August 18, 2021

Marlon Pangilinan, emailed
Senior Planner, City of San Diego
Planning Department

Regarding: Clairemont Community Plan Update, Community Discussion Draft May 2021 Draft

San Diego Tennis and Racquet Club

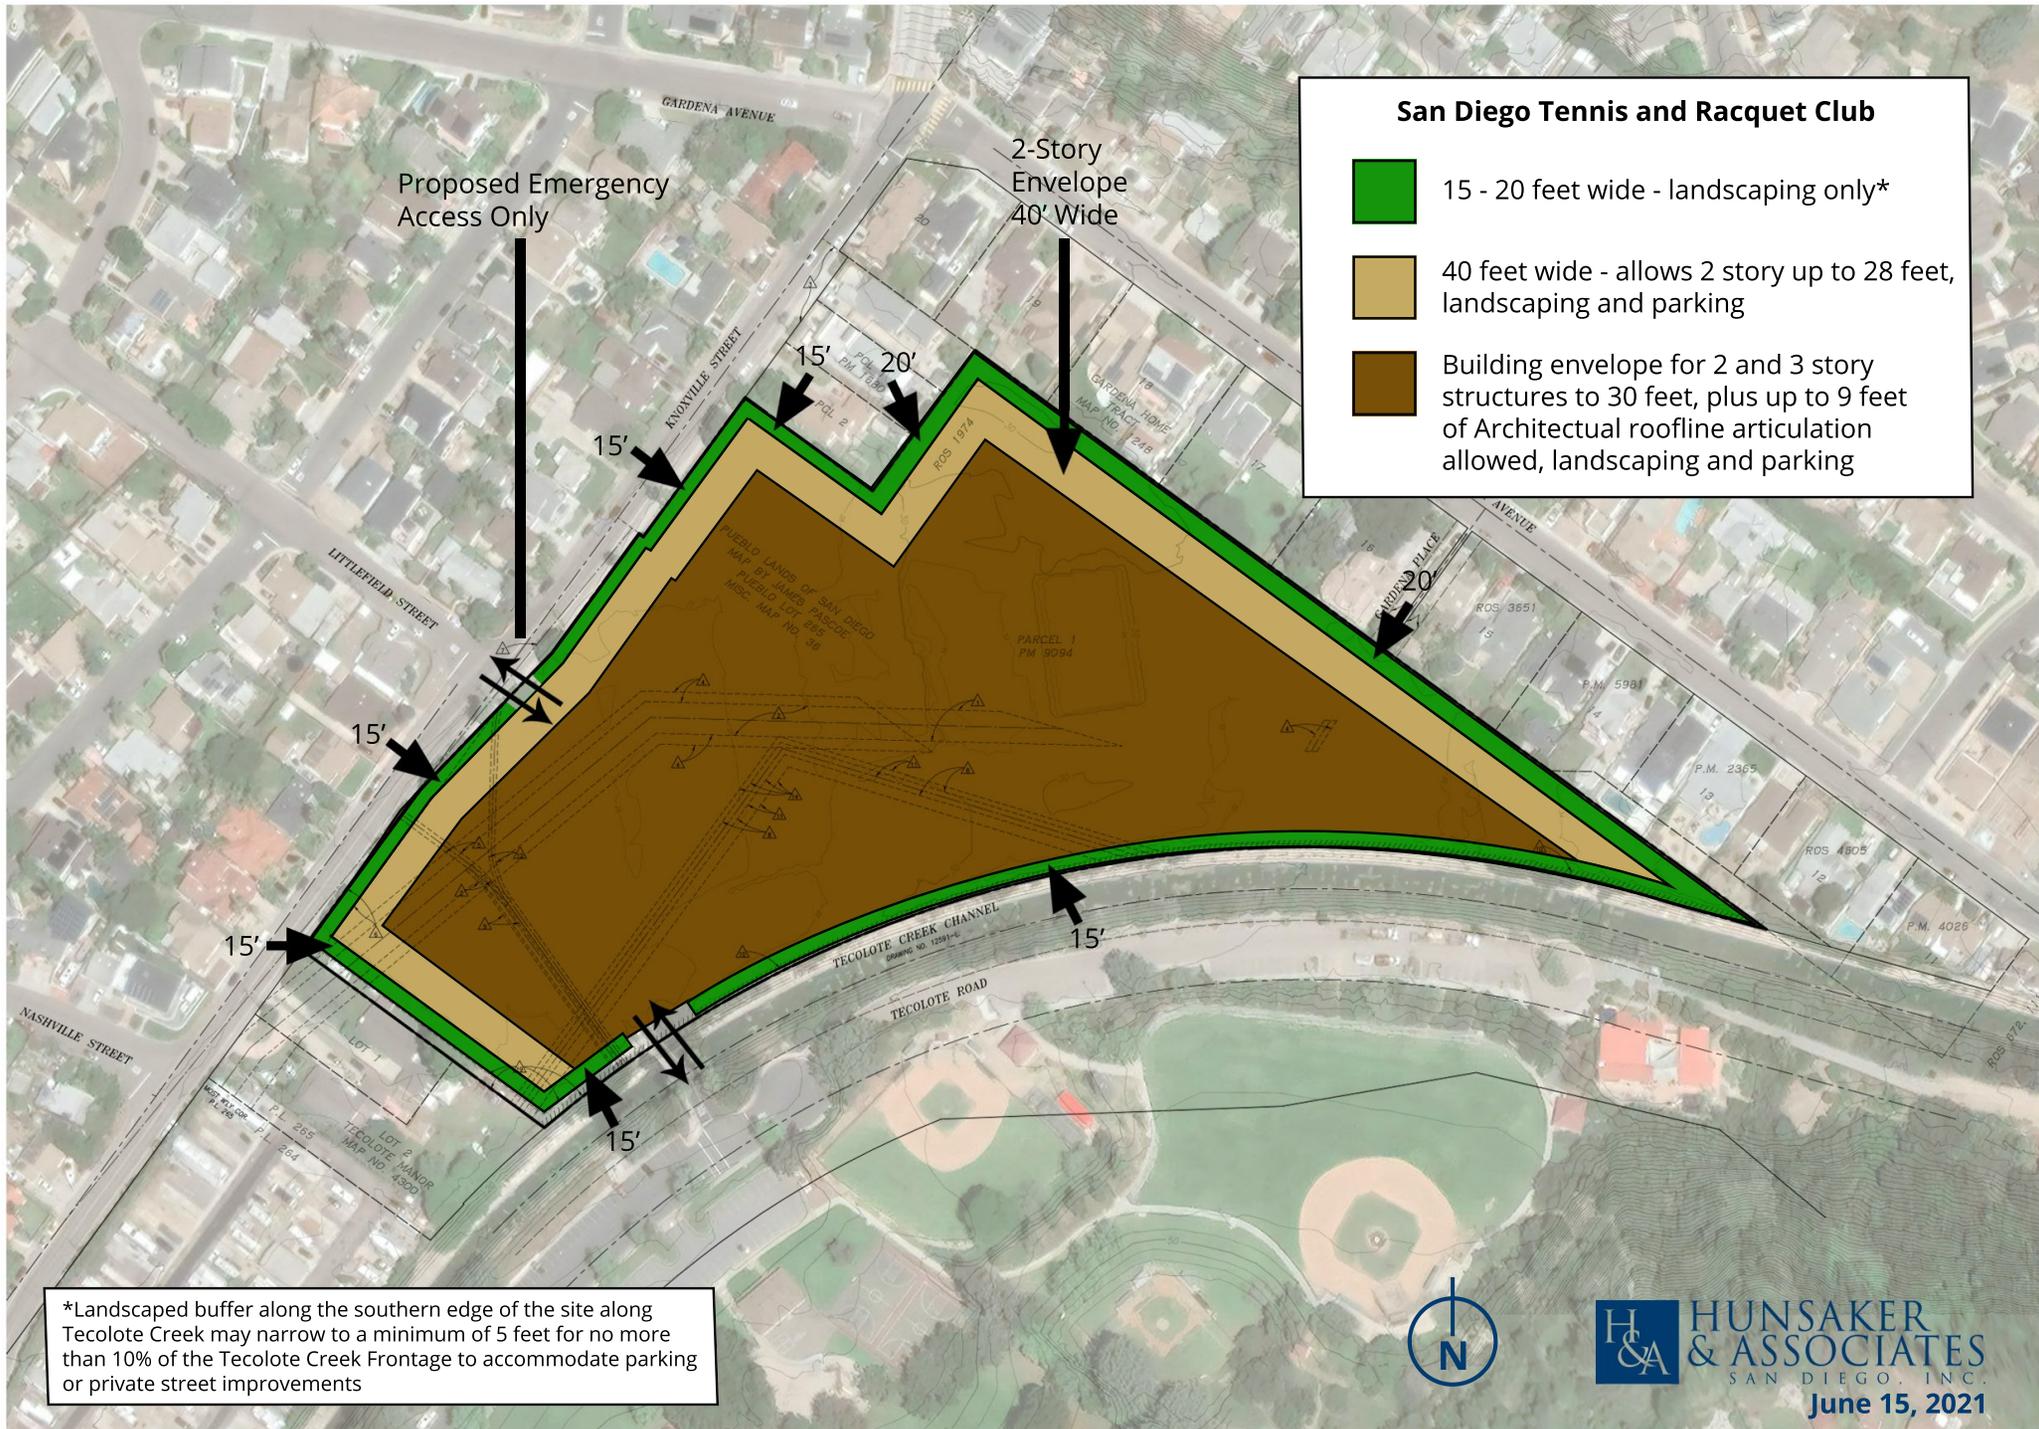
The plan update should include a dedicated left-turn lane on Tecolote Road at the entry to the proposed development. The plan should also include “Keep Clear” indications on Tecolote Road at the Tecolote Canyon recreation facility parking lot ingress/egress. The plan should include consideration of other traffic calming measures for Tecolote Road such as speed humps and traffic circles. Additionally, no street parking on Tecolote Road should be removed.
